11 July 2025

Wellington International Airport Ltd Southern Seawall Renewal – Wastewater and Stormwater Interface

Moa Point Outfall and WIAL Sea Defences Renewal Interface Meeting

WIAL SEA DEFENCE STRUCTURES RENEWAL STAGE 1 KORORA HABITAT GENERAL ARRANGEMENT & UNDERPASS SECTION CIVIL ENGINEERING

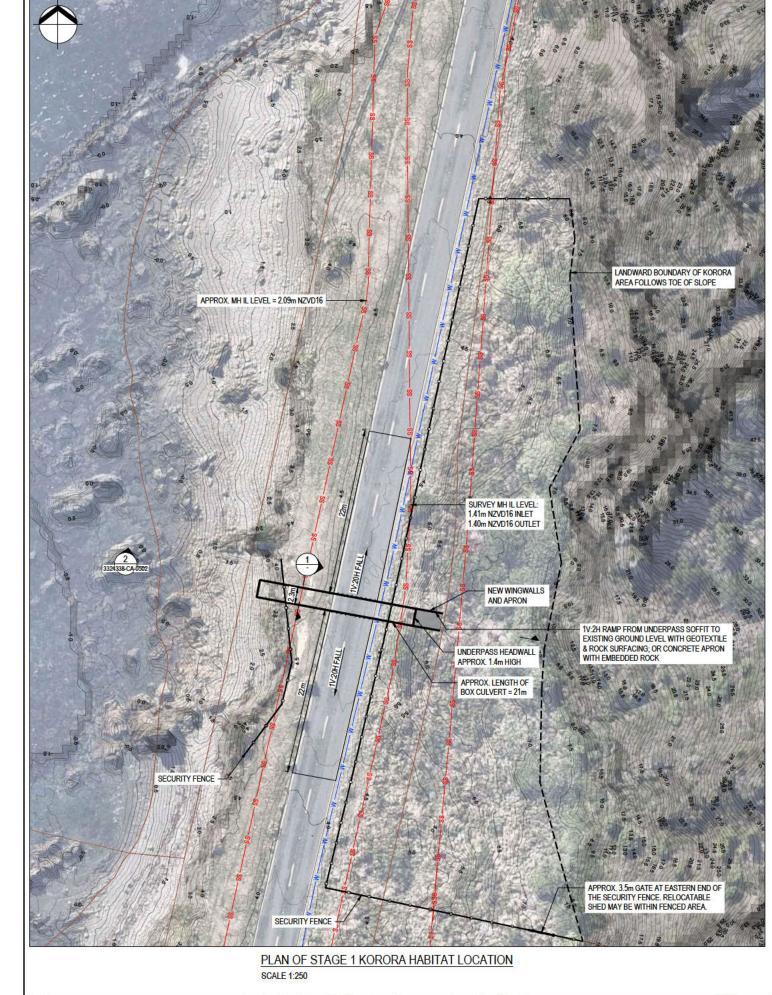
- The works will avoid the emergency wastewater overflow gravity pipelines, which we understand from
 Wellington Water are presently not carrying any flow but which remain available for use, on eastern Moa
 Point Road; with a 0.1m clearance between the proposed small underpass and existing pipeline locations
 as requested by Wellington Water, as far as these existing locations are known from Wellington Water's
 information and site survey (refer to drawing 3324338-CA-0501).

- The existing potable water pipe on eastern Moa Point Road will be slightly relocated e.g. beneath the proposed underpass as indicated by Note 4 on drawing 3324338-CA-0501.

WELLINGTON WASTE WATER PROJECT OCEAN OUTFALL Drawing No. GENERAL ARRANGEMENT 951096 OCEAN OUTFALL

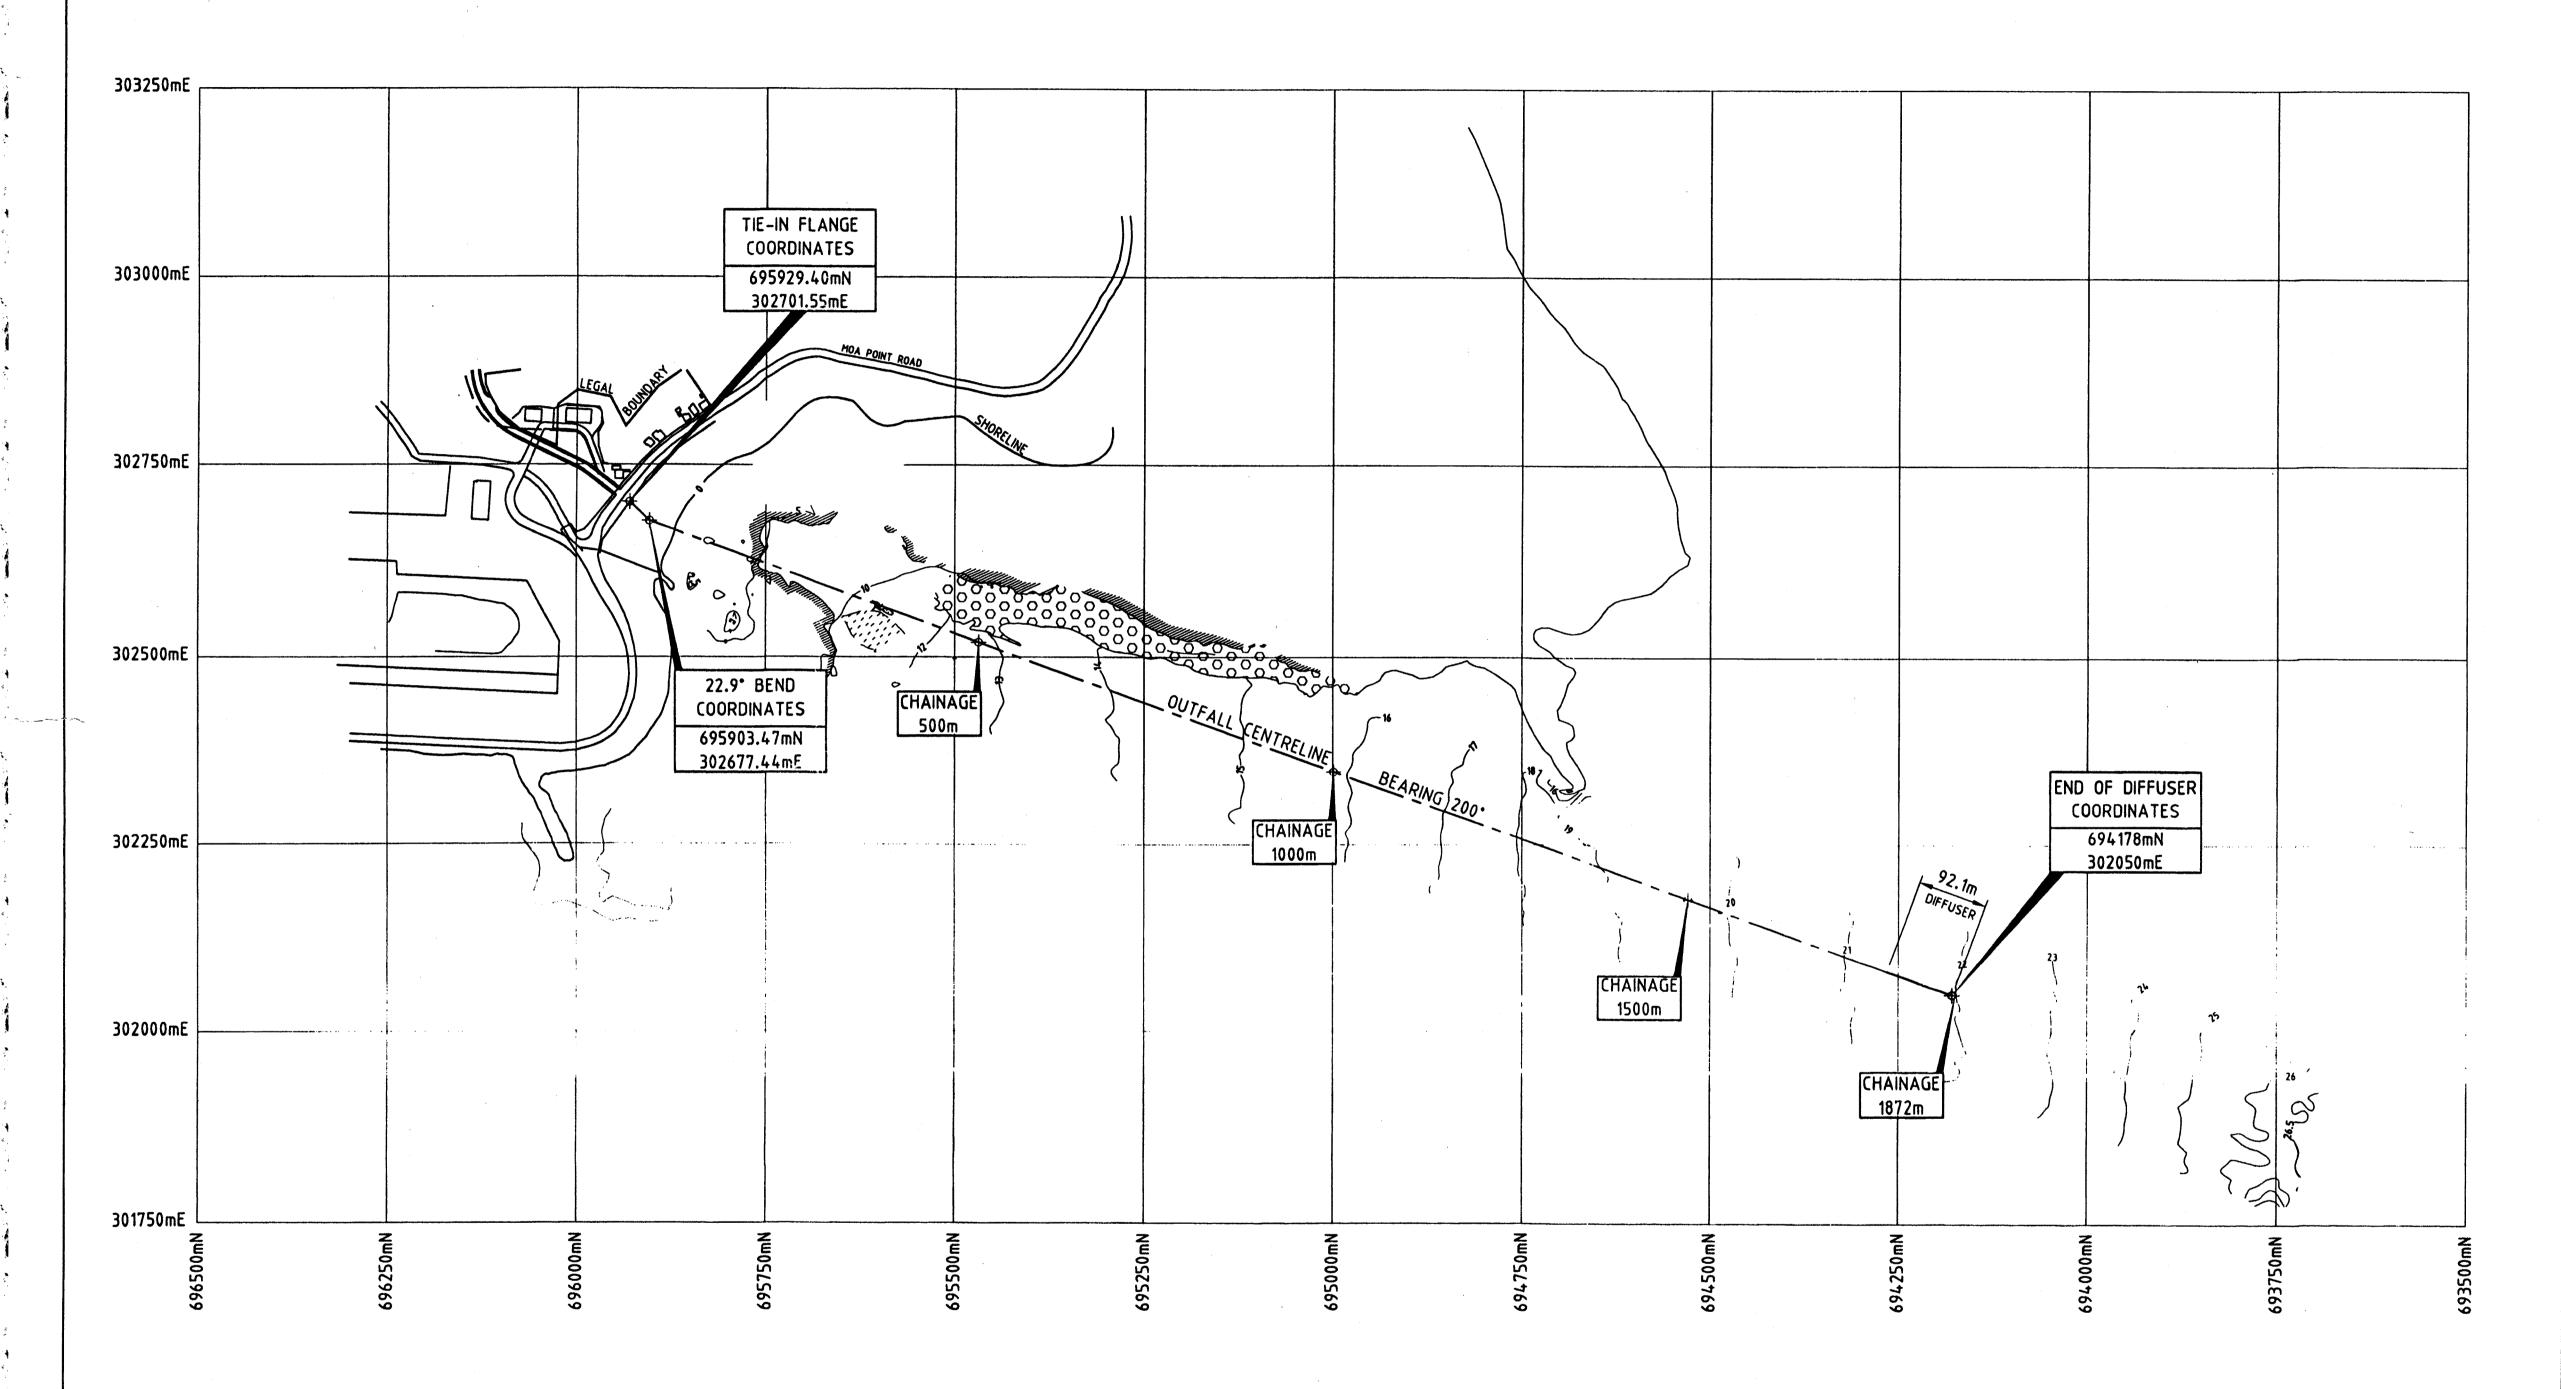
- The location of Moa Point outfall has been estimated from Wellington Water's As-built Drawings and a recent Beca survey. The exact location of the pipe (in plan and level) at the eroding bank cannot be precisely established due to inconsistencies between the As-built Drawings and present-day information however it appears that the outfall is close to being exposed by erosion.

- Wellington Water noted the Mean Sea Level (MSL) vertical datum on the Asbuilt Drawings is WVD1953, and that typically 900mm cover would be needed over a wastewater pipe.
